Regulation No. 110 (CNG and LNG vehicles)

Proposal for amendments to Regulation No. 110 (CNG and LNG vehicles)

Submitted by the experts from the Netherlands and International Association for Natural Gas Vehicles *

Figure 1
Dimensions of the receptacle

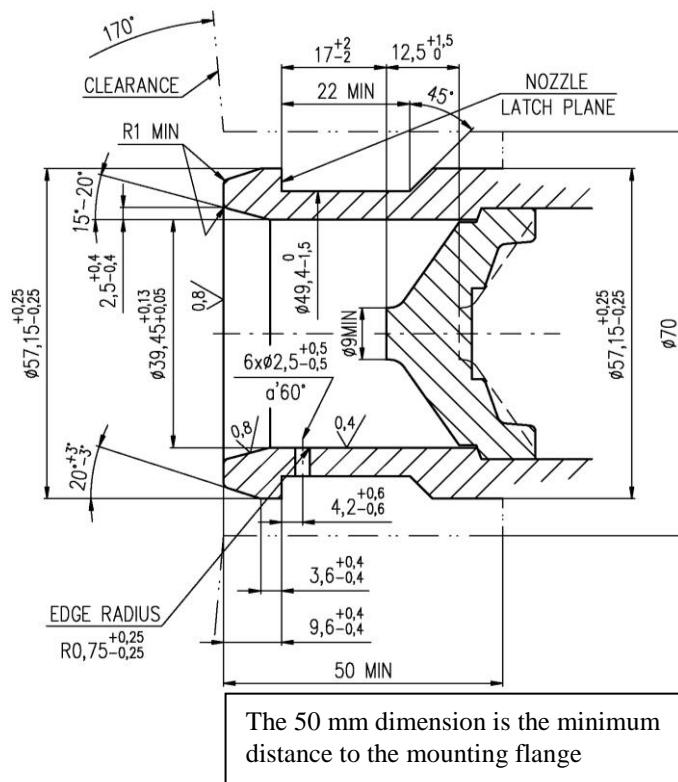
Insert new paragraphs 4. and 4.1., to read:

"4. LNG filling unit dimensions

4.1. Figure 1 shows the dimensions of the LNG filling unit.
